DTB

Date: June 4, 2008
 Order No.: S-B-09.20/29
 Supersedes:
 Group: 09

SUBJECT: Model 164.122/822
Model 211.022
Model Sprinter Van
Models Equipped with Engine OM642 BlueTec Diesel

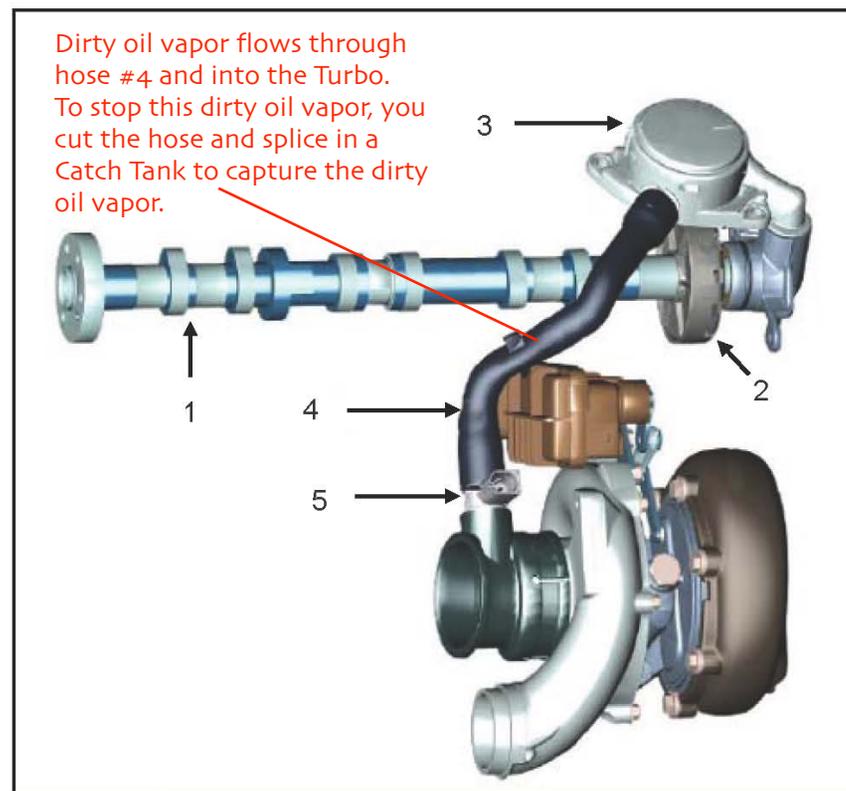
This seal was not installed wrong. Every seal does this. The seals were installed at the factory. The seal is drenched with oil. The Turbo sucks in air so hard that it tries to suck in this seal. The volume of air being sucked in is also sucking oil out of the crankcase ventilation system. This can be stopped. This happens to every OM642 and OM651 BlueTec from 2007 to 2020.

In this Service Bulletin Mercedes shows us a red seal that's deformed. Mercedes says the seal was installed wrong. This seal was installed by the factory. They all deform like this because they're soaked in oil and the Turbo is sucking so much air at full throttle. To slow down the oil going into the Turbo, Mercedes has updated the Oil Separator (PCV valve) 14 times. In Europe, Mercedes redesigned the Crankcase vent system and installed a sophisticated version of the Catch Tank. Mercedes won't do that for the North American market because they would have to recall every BlueTec they've ever built. The goal is to stop the oil from leaving the crankcase. If you have a 2018 or older BlueTec, the Oil Separator is one of the first things that needs to be replaced. The older the engine, the more out dated the Oil Separator. Oil that's designed to withstand extreme temperatures, fuel dilution and soot, is the other part of the puzzle. This is also what I help owners to understand and choose an oil that's best for their situation.

Mercedes is telling their mechanics this oil in the Turbo is normal. It's not normal. It's also not the Turbo's fault. Replacing the Turbo won't stop the oil. Mercedes has never fixed this problem on the North American versions of this engine. It is still a problem in 2020. There is however a way to mitigate the damage being done by this oil. The leak and the red oil seal are not the problem. The problem is the incredible amount of sludge this oil causes inside the engine. It seems impossible, but sooner or later this oil will bring the engine to a grinding halt right in the middle of the road.

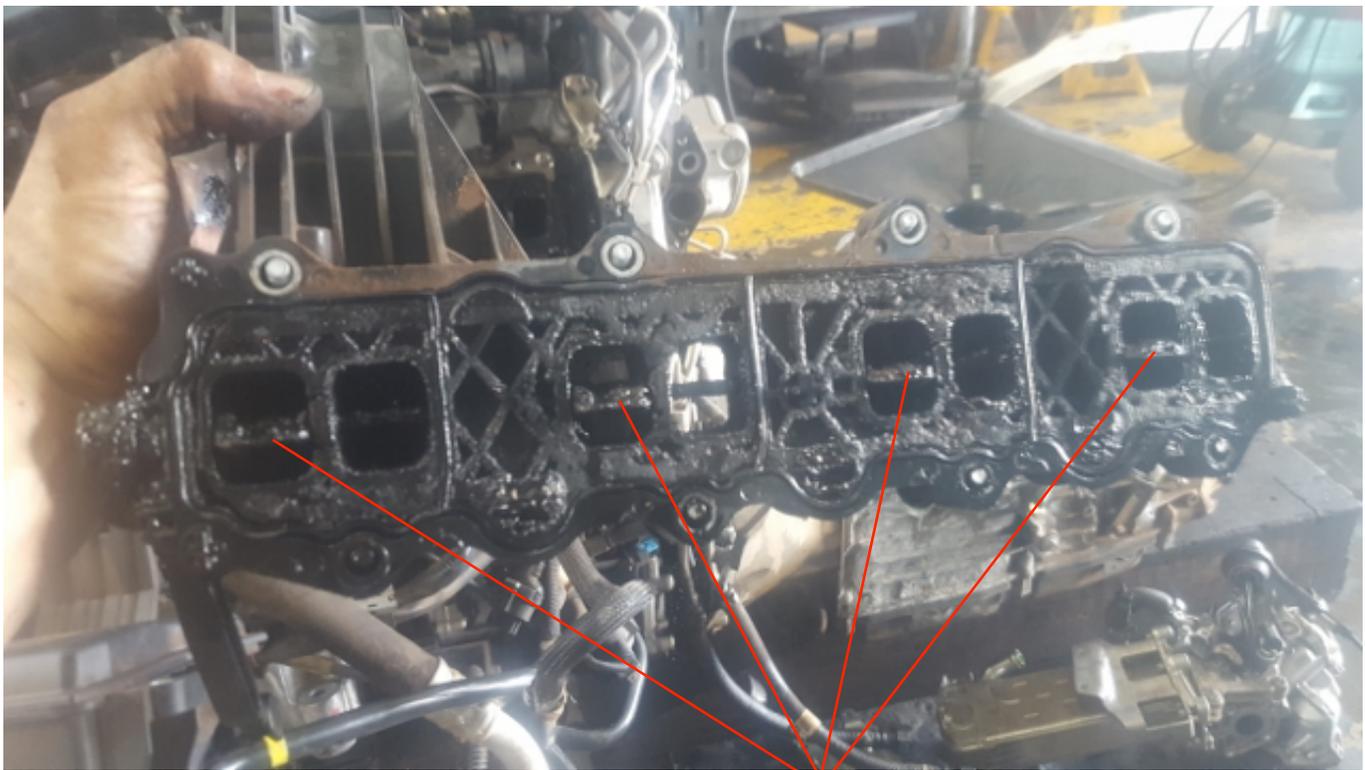
This is what bore polishing looks like in a BlueTec diesel. It was caused by the friction modifiers in Mobil One 5W/30 ESP. Blow-by and excessive crankcase pressure occurs where you see the glazing. In a gas engine, this is bad, but not the end of the world. However, when a BlueTec diesel regenerates the DPF, this glazing allows diesel fuel to enter the crankcase. Soot in the diesel fuel gets into the oil and causes the glazing to worsen. To remove this glazing, you need to use motor oil without the fuel efficiency friction modifiers. Motorcycle oil doesn't have the friction modifiers that cause the glazing. Over time, motorcycle oil will gradually clean off the glazing and return the cylinder walls to their normal look.

Glazed cylinder walls are also caused by excessive idling or slow stop and go city driving. The piston rings are designed so higher RPM's creates more combustion gas that pushes the piston rings tight against the cylinder walls.
